REVIEW NOTES
GUILFORD BRO 1442(36) – BRIDGE NO. 65
TRAFFIC CONTROL PLAN
July 15, 2014

RE: Temporary Traffic Control Plan received from Renaud Bros. Inc on 7/08/2014.

This submittal review is for sheet 1, inclusive, of the
 “Guilford 1442 (36)-Traffic Control 002” submittal received on 7/08/2014.

TRAFFIC CONTROL ROAD CLOSED TO NOT TO SCALE

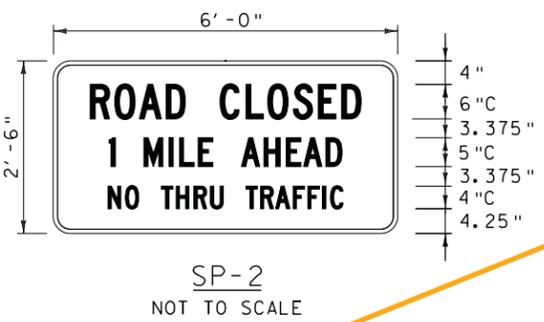
Multiply barricades should be used so they extend across the entire roadway width

Is there a reason barrier is being chosen in place of Type III barricades? If barrier is essential, consider a row of Type III barricades (with the ROAD CLOSED sign mounted on one of them) in advance of the row of barriers. The barriers should have plenty of delineation on them to make them visible at night.

500' distance to the first W20-3 sign should start at the Road Closed sign and barricades. All remaining signs should be adjusted as required to maintain the spacing shown.

Don't need to spec FW, there is no such thing as fluorescent white. (Type IX white exists, but it's not fluorescent). B/W is fine to specify here.

Multiply barricades should be used so they extend across the entire roadway width

500' distance to the first W20-3 sign should start at the Road Closed sign and barricades. All remaining signs should be adjusted as required to maintain the spacing shown.

WE ARE FIGURING THAT THE 6 DAY GLOW SIGNS WILL STOP THE TRAFFIC AND IF THEY DO NOT THE TYPE III BARRICADES WILL NOT. HAVING THE CARS STOPED AT THE JERSEY BARRIERS RATHER THEN IN THE CONSTRUCTION SITE OR RIVER WOULD BE PREFERABLE.

NOTE: THE EIGHT W20-3 SIGNS ARE ASTM TYPE VIII OR IX RETRO-REFLECTIVE FLUORESCENT ORANGE BACKGROUND.
